**Re: Third Submission Review** – Lona / Forum Vista Creek – Master Plan, Site Plan and Final Plat  
Application Number: **DA-2248-01**  
Case Numbers: **2021-7009-00; 2021-4025-00; 2021-3051-00**

*Third Submission Review*

# LONA | SITE PLAN

SHEET TITLE:  
COVER SHEET

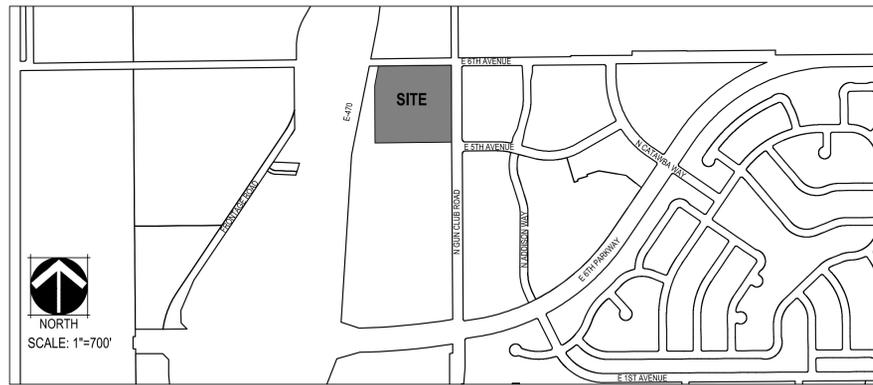
Change ADA to accessible TYP.

ADA has been changed to "Accessible" throughout plans

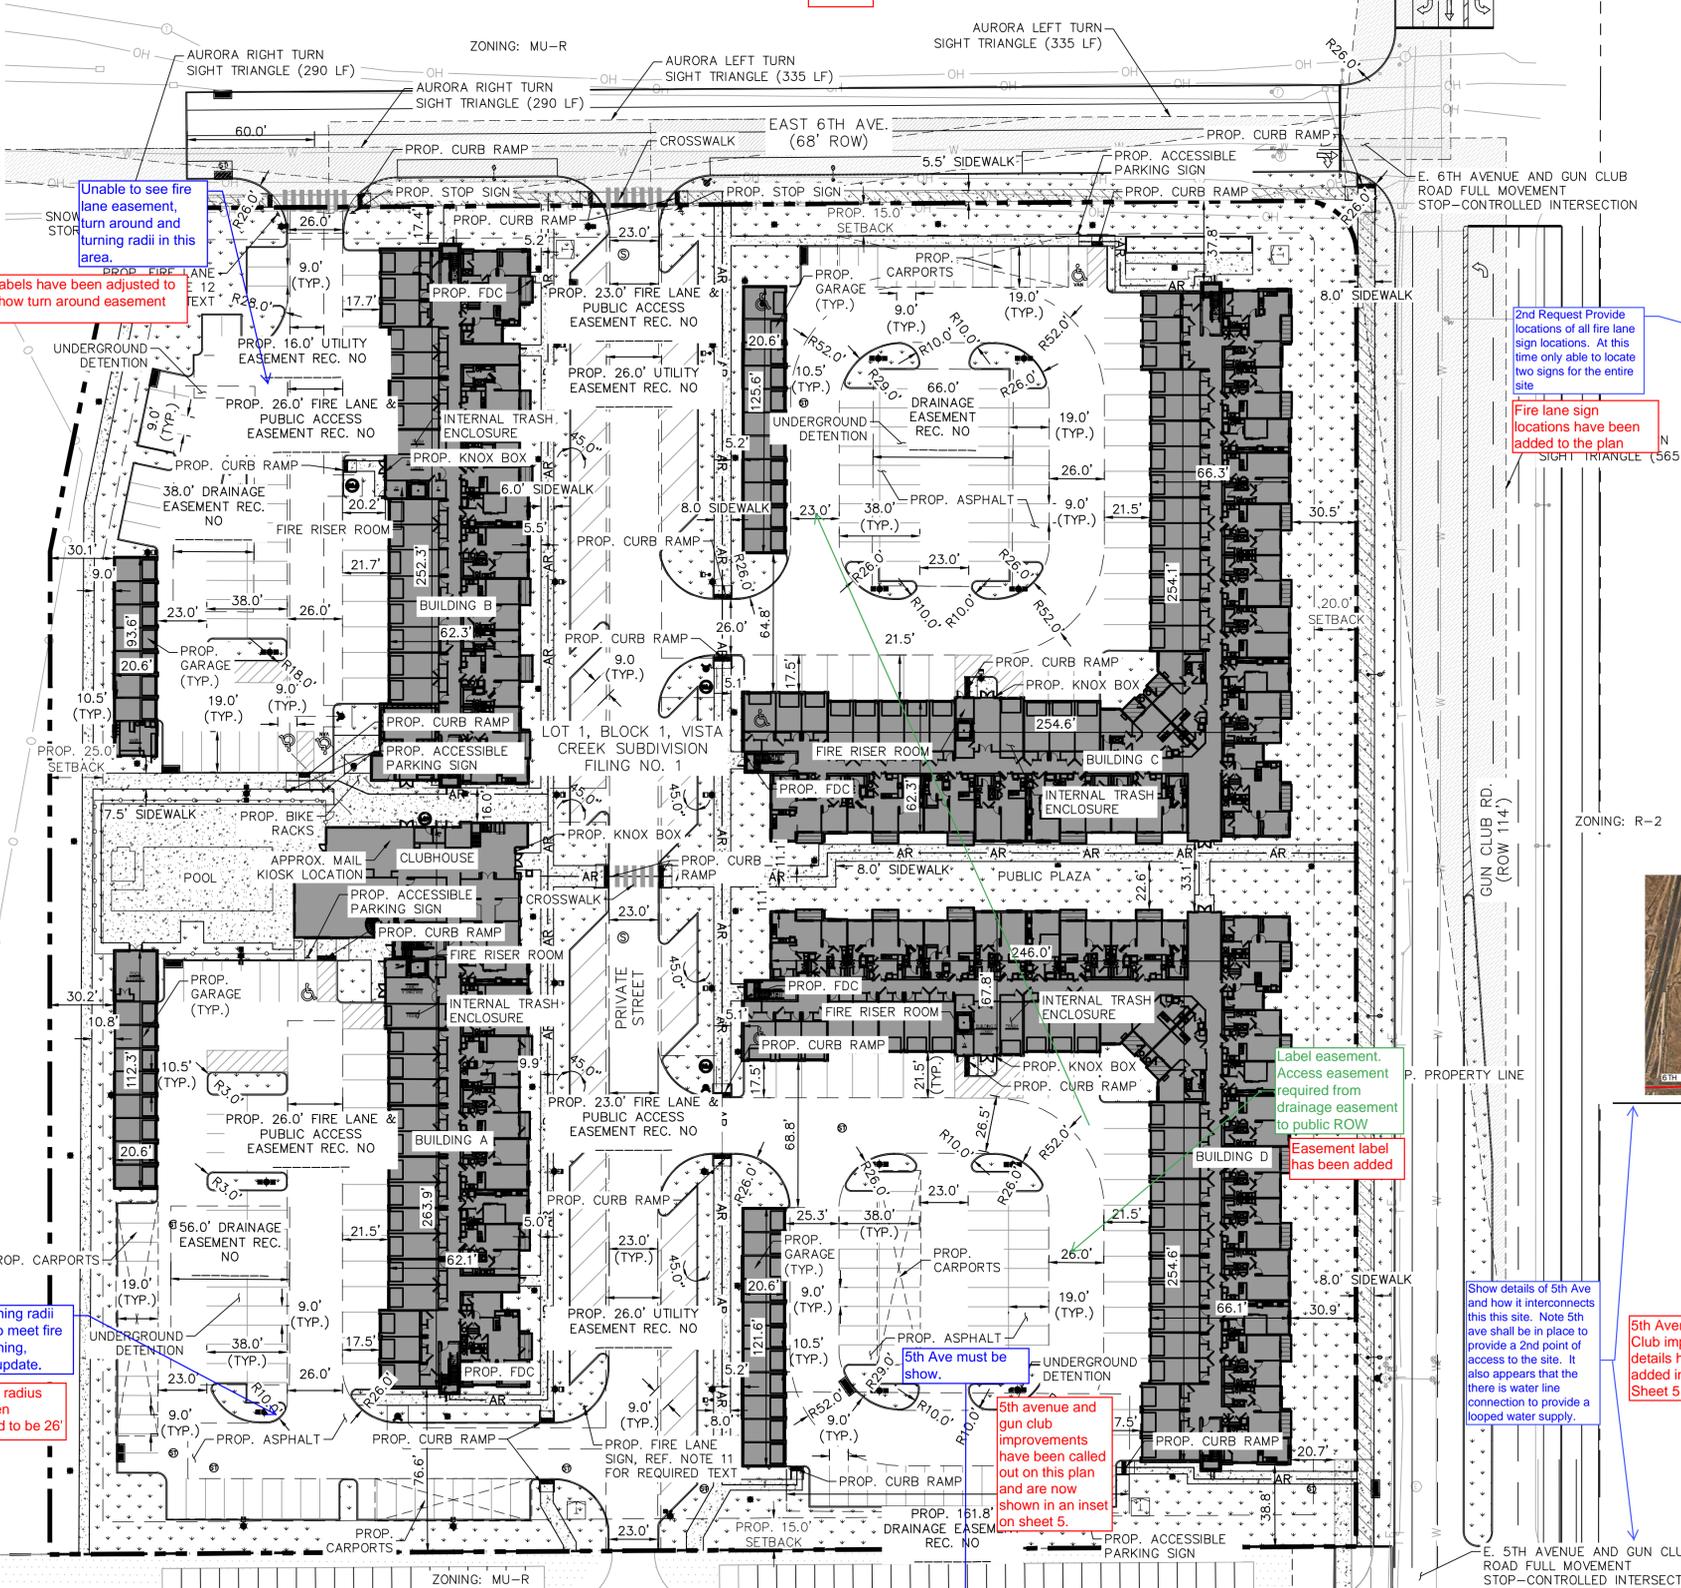
Unable to see fire lane easement, turn around and turning radii in this area. Labels have been adjusted to show turn around easement

2nd Request Provide locations of all fire lane sign locations. At this time only able to locate two signs for the entire site. Fire lane sign locations have been added to the plan

On this sheet or another sheet provide accessible ramp detail including slope

This turning radii needs to meet fire lane turning, please update. Turning radius has been modified to be 26'

Label easement. Access easement required from drainage easement to public ROW. Easement label has been added

Show details of 5th Ave and how it interconnects this site. Note 5th ave shall be in place to provide a 2nd point of access to the site. It also appears that there is water line connection to provide a looped water supply.

5th Ave must be shown. 5th avenue and gun club improvements have been called out on this plan and are now shown in an inset on sheet 5.

A typical curb ramp detail has been added to this sheet

5th Avenue and Gun Club improvement details have been added in an inset of Sheet 5
